**Operator: CIVITAS NORTH LLC**

**Location Name: Hunt 8-60 6C**

**Loc ID: 454166**

**Inspection: 709100215**

**Exhibit C**

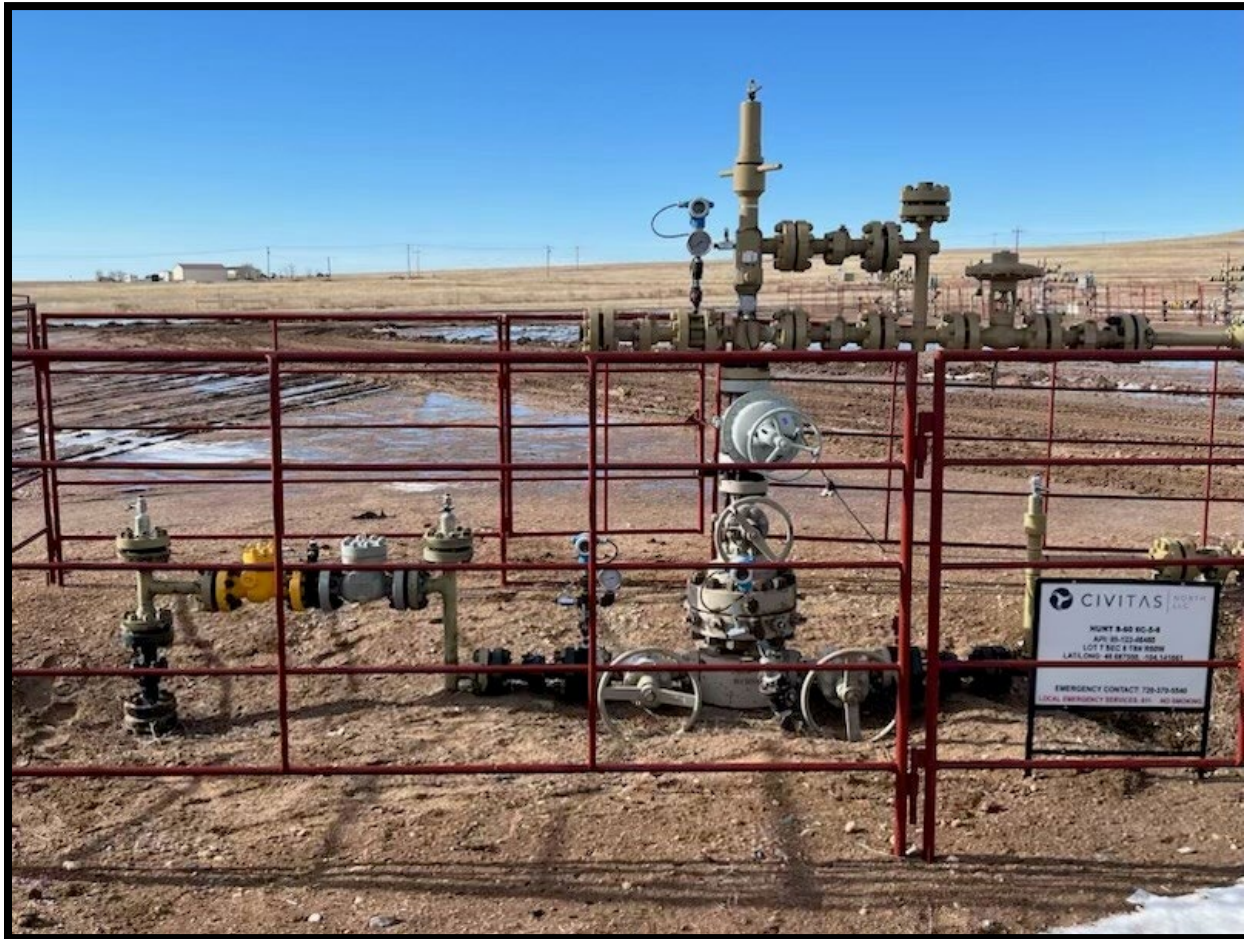
**CA:** Wellhead sign not properly installed. Comply with Rule 605.d.

**CA Resolution:** Operator has fixed and appropriately installed identified Wellhead signs to comply with Rule 605.d.

**Exhibit A**

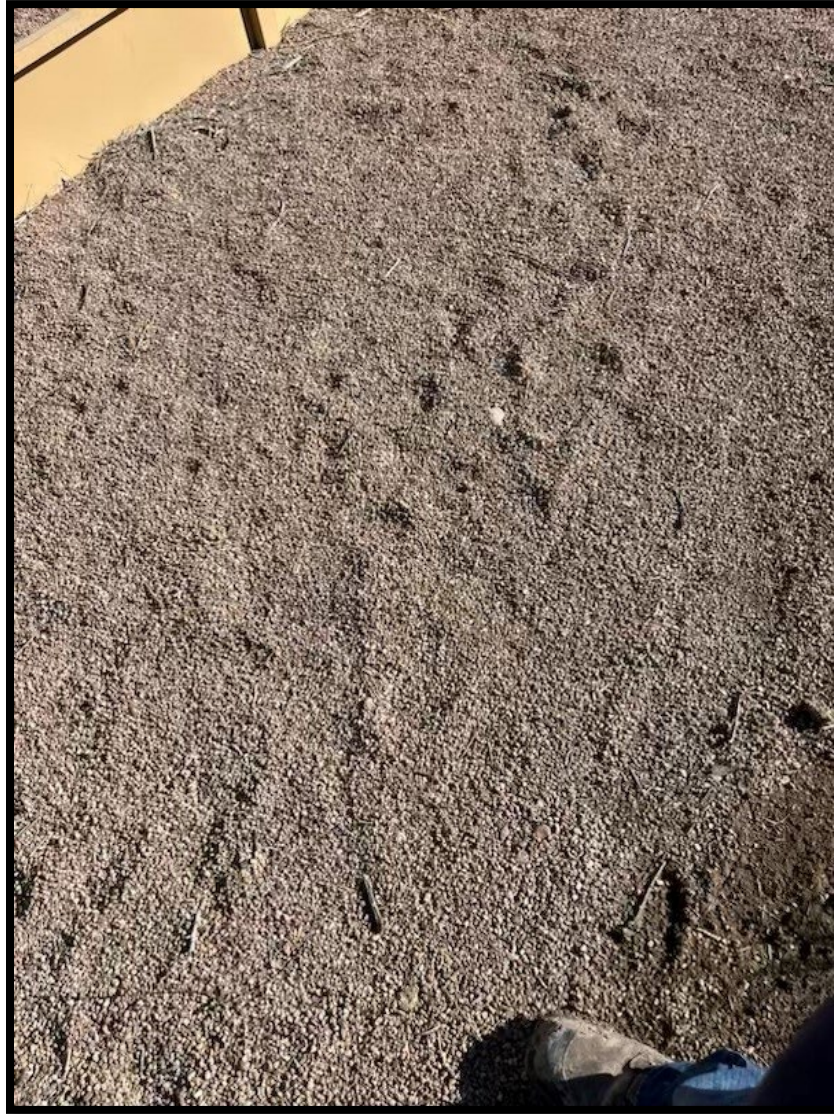
**CA:** Unused equipment (metal pipe, extra signs, spool of tubing, wiring, screws and nuts) observed on location. Comply with Rule 606

**CA:** Trash observed throughout location and among the wellheads. See photo documentation. Comply with Rule 606

**CA Resolution:** Operator has removed identified equipment from the location to comply with Rule 606.

**CA Resolution:** Operator has removed identified trash, debris, and tumbleweeds to comply with Rule 606.
